# Economic and Social Council

## Proposal for 01 Series of Amendments to UN Regulation No. 166 (Vulnerable Road Users in Front and Side Close Proximity)

### Submitted by the Working Party on General Safety Provisions\*

Figure 1  
**Example for the measurement by maximum variation**

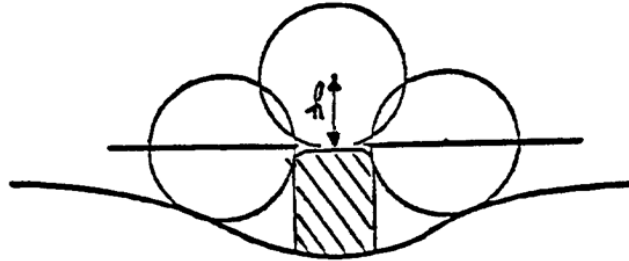
6.1.3.3.2. If the dimension of the projection of a component which is mounted on a surface other than convex cannot be determined by simple measurement, it shall be determined by the maximum variation of the distance of the centre of a 100 mm diameter sphere from the nominal line of the panel when the sphere is moved over and is in constant contact with that component. Figure 1 shows an example of the use of this procedure.

Figure 2  
**Dimensions of the Test Rig and the Special Design**  
 (in millimeters)

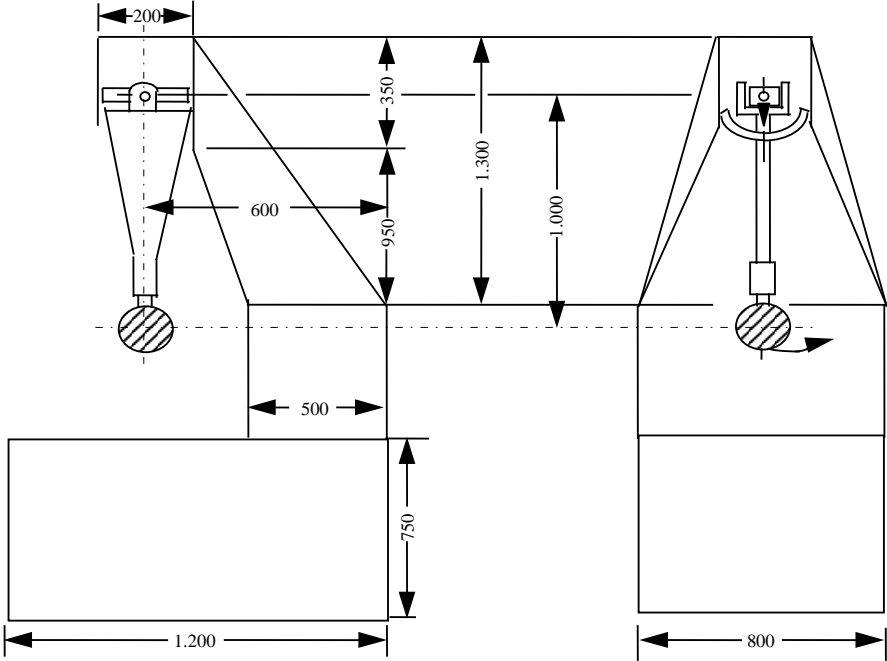
Figure 2 below gives the dimensions (in mm) of the test rig and the special design specifications:

Figure 3  
Example of Mirror Bending-Test Rig

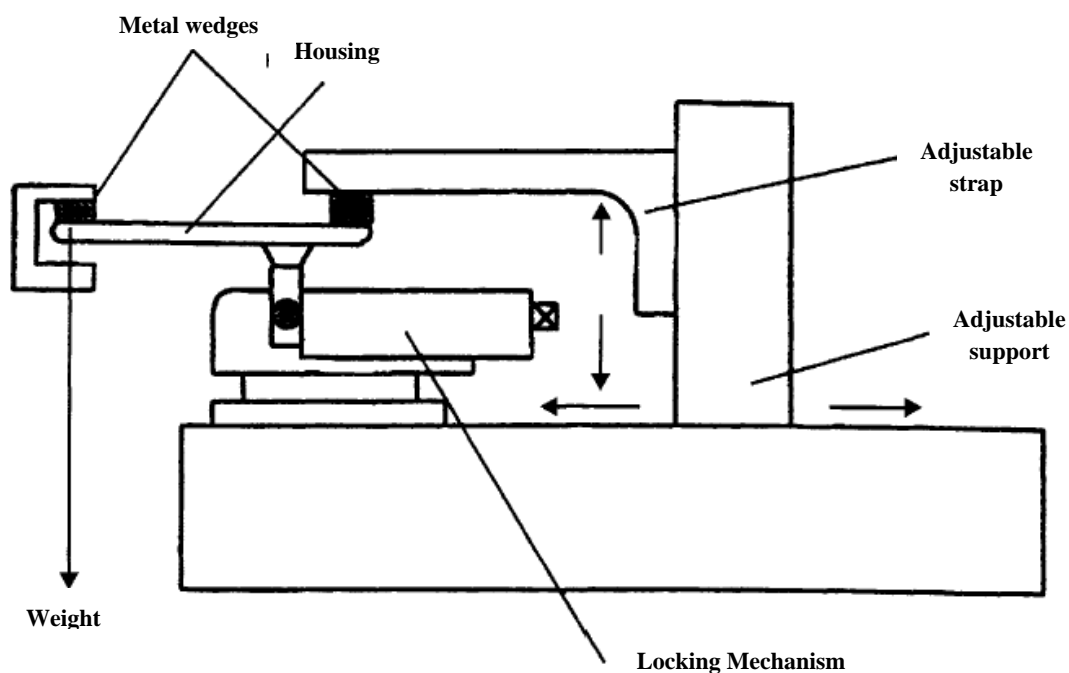
At the other end, a stop identical to the one described above is placed on the housing so that the specified test load can be applied to it (Figure 3).

The end of the housing opposite to that where the force is exerted may be locked rather than held in position as shown in Figure 3.

Figure 4  
**Monocular Fields**  
**(Direct vision case)**

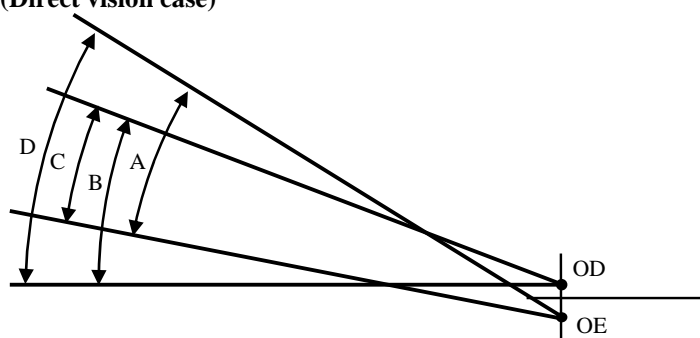
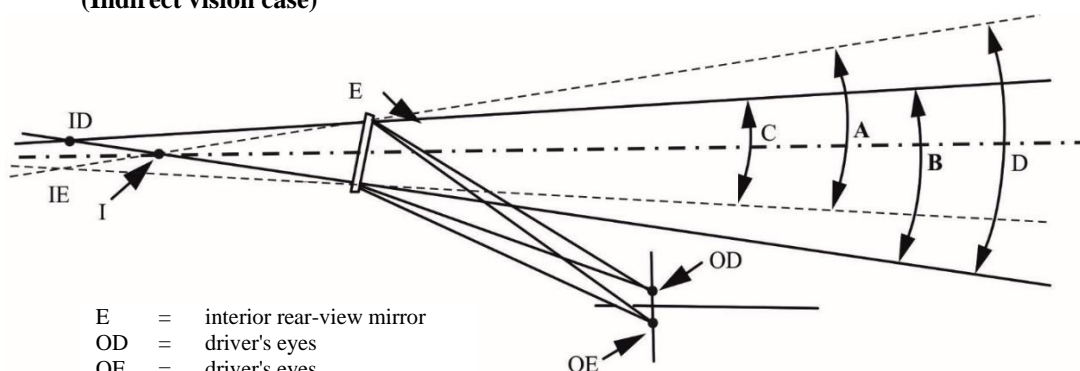
*Paragraph 12.2., amend to read:*

"12.2. *"Ambinocular vision"* means the total field of vision obtained by the superimposition of the monocular fields of the right eye and the left eye (see Figure 4 below).

Figure 5  
Examples of Designated Area of Each Means (Right-Handed Drive Case)

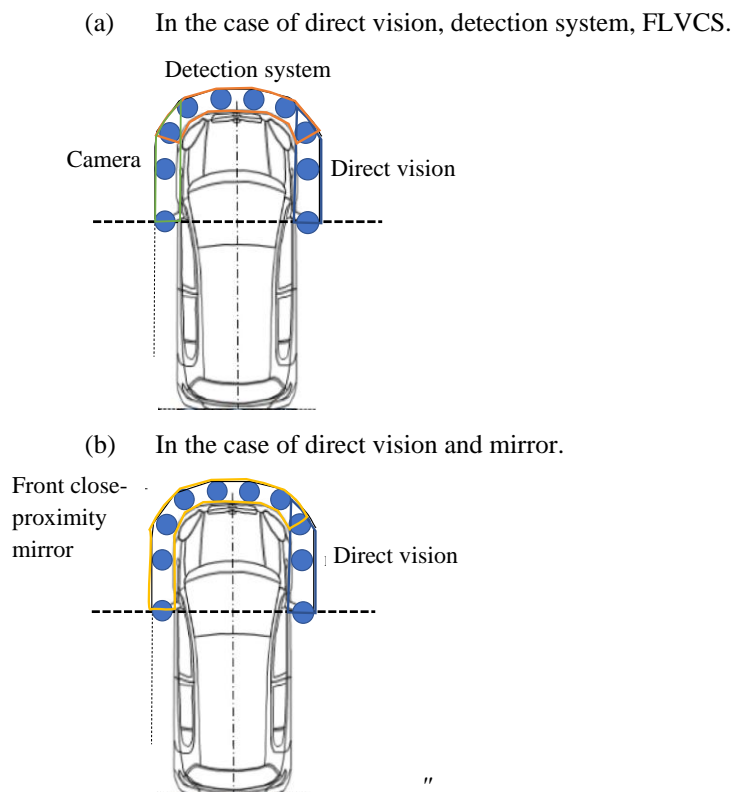
Overlaps of designated areas by different means (see examples in Figure 5) shall be permitted.

Figure 6  
Close-Proximity Front and Lateral Sides View Field of Vision

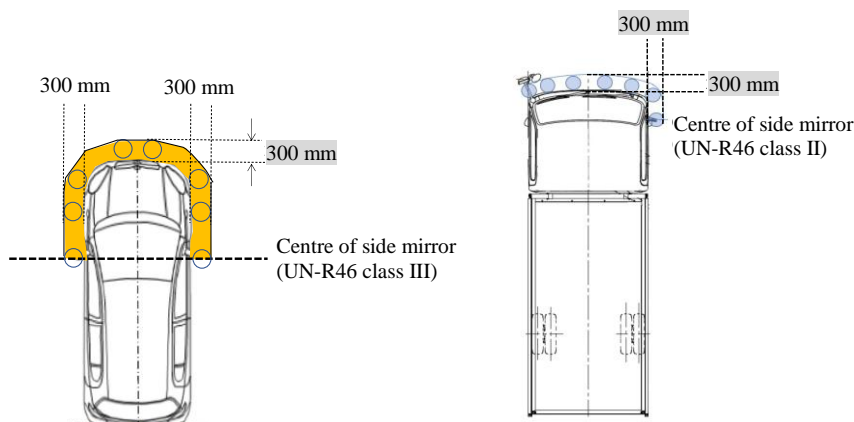
Paragraph 15.2., delete Figure 2 and amend to read:

The field of vision (see Figure 6 below) shall be bounded by the following planes:

- A longitudinal vertical plane passing through a point 300 mm from the contour of the sides of the vehicle;
- A transverse vertical plane passing through a point 300 mm from the contour of the front of the vehicle;
- Areas ahead of the centre of the side mirrors on the driver's seat side and the passenger seat side. In the case of the vehicle that equipped with CMS that comply UN Regulation No. 46, 04 Series of amendments, the manufacturer shall consider the same vehicle equipped with side mirrors or to use the centre of Class III or II CMS camera lens instead of the centre of the side mirrors.

Figure 7  
**Example for the Measurement by Maximum Variation**

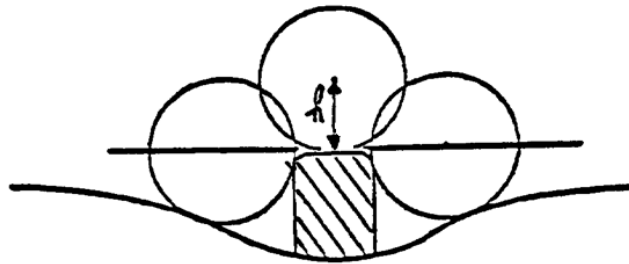
15.4.3.2.2. If the dimension of the projection of a component which is mounted on a surface other than convex cannot be determined by simple measurement, it shall be determined by the maximum variation of the distance of the centre of a 100 mm diameter sphere from the nominal line of the panel when the sphere is moved over and is in constant contact with that component. Figure 7 shows an example of the use of this procedure.

### Arrangement of Approval Mark for a Device for Means of Front and Lateral Vision

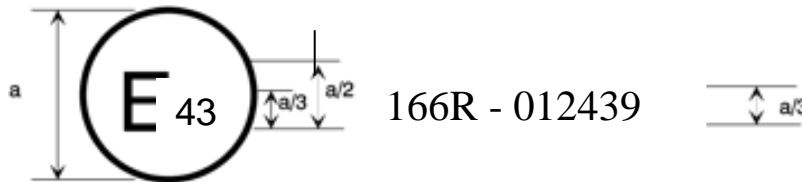
*Annex 5*, amend to read:

The above approval mark affixed to a device for means of front and lateral vision indicates that the device is a main close-proximity front and lateral view device, which has been approved in Japan (E 43) pursuant to UN Regulation No. 166 and under approval number 012439. The first two digits of the approval number indicate that UN Regulation No.166 already included the 01 series of amendments when the approval was granted. ..."

Figure 2  
Test Object Locations

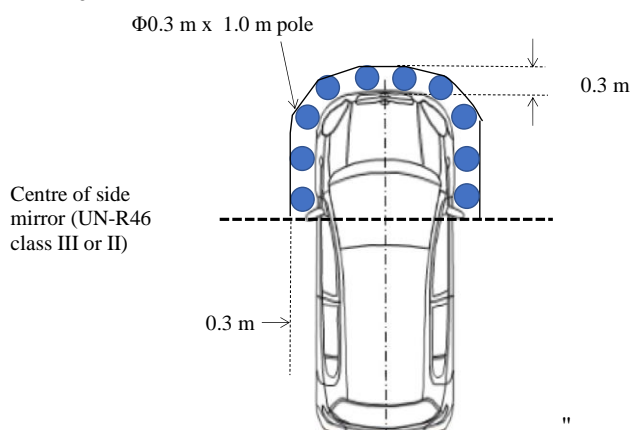
*Annex 9, paragraphs 1.2.*, amend to read:

- "1.2. The test object shall be in contact with the vehicle's front and lateral side from the centre of passenger side mirror to driver's side mirror shall be seen in the close-proximity front and lateral view field of vision. In the case of the vehicle that equipped with CMS that comply UN Regulation No. 46, 04 Series of amendments, the manufacturer shall consider the same vehicle equipped with side mirrors or to use centres of Class III or II CMS camera lens instead of the centres of the side mirrors.

**Necessity of Pendulum Impact Test**

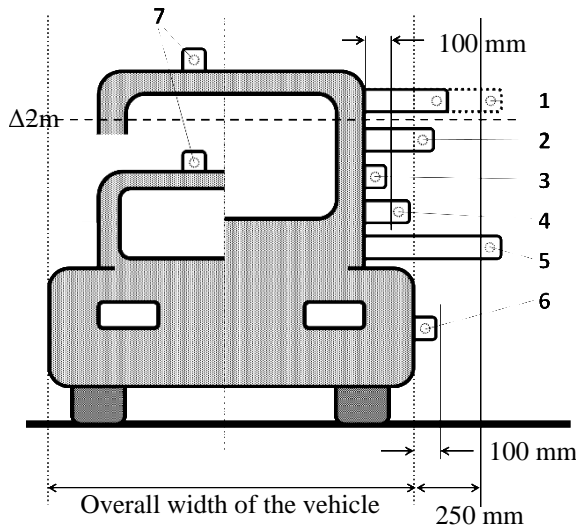
Insert new Annex 13, to read:

PENDULUM IMPACT TEST	
<u>Device for indirect vision (mirrors)</u>	
1	NO TEST
2	COMPULSORY
3	NO TEST
4	NO TEST
5	not permitted
6	NO TEST
<u>Device for indirect vision (FLVCS)</u>	
7	NO TEST
